Modification Recommended Service Note

Supersedes:
MSOS054A-02E

MSOS054A – MSO Infiniium S Series 500MHz 4 channel

The Problem – Under certain circumstances a PLL2 error may occur on the S-series products.

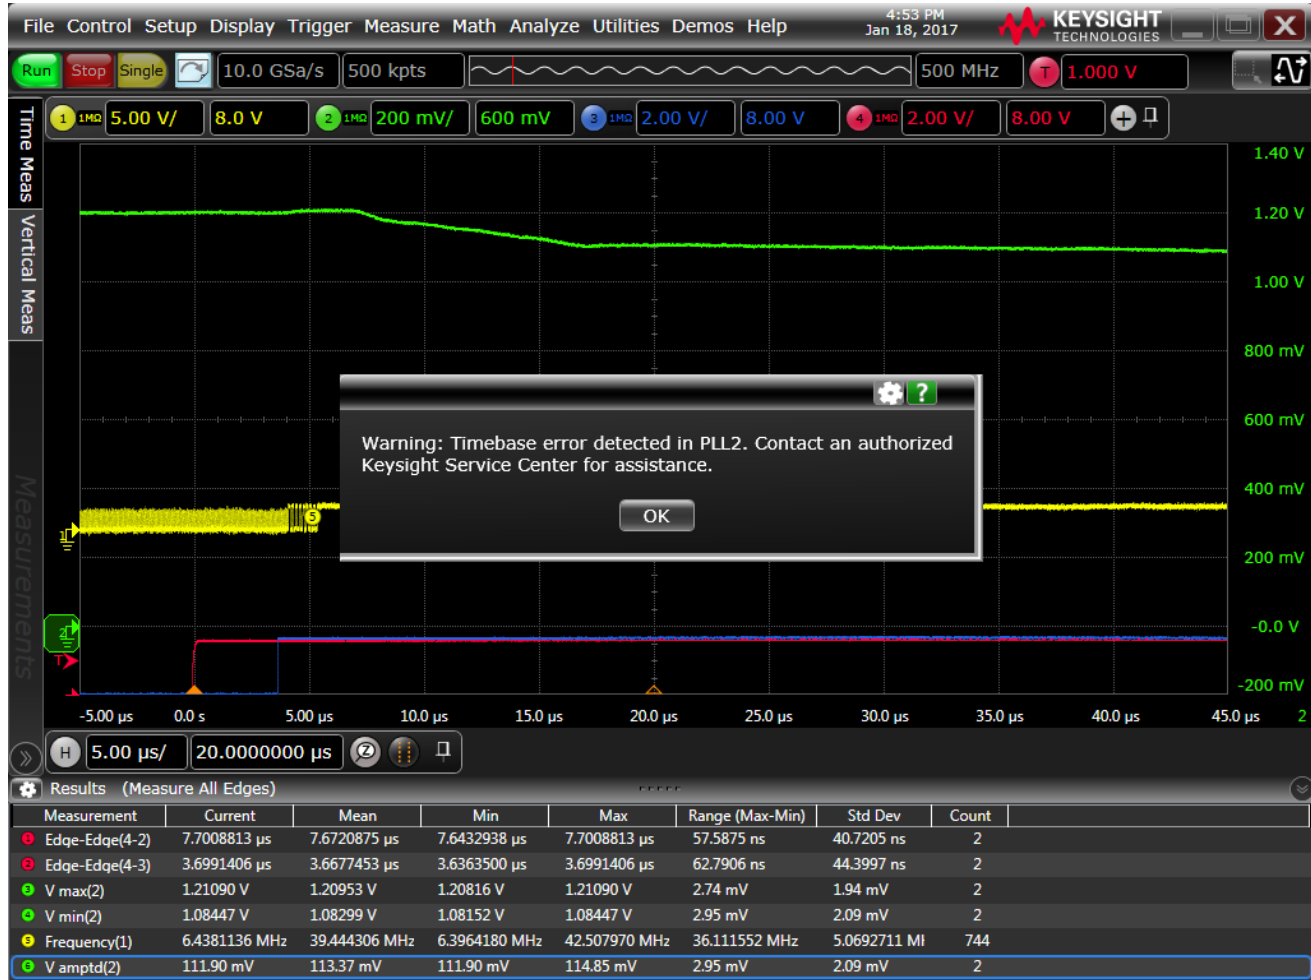
On older acquisition boards a PLL2 error message sometimes occurs. The error message appears on the screen as below:

There are new acquisition boards that fix this issue for the S-series scopes.

Please, use the 54911-69511 board until is gone.
If you have a 54911-69511, then skip steps 1 and 2 and proceed to step 3.
If there are no 54911-69511, then start with step 1 below.

1. If the customer needs to have software revision < 6.10.01001, then replace the acquisition board with the 54911-69532 board.
2. If the customer can have software revision \geq 6.10.01001, then it can be replaced by any of these three boards: 54911-69521, 54911-69531, or 54911-69532.
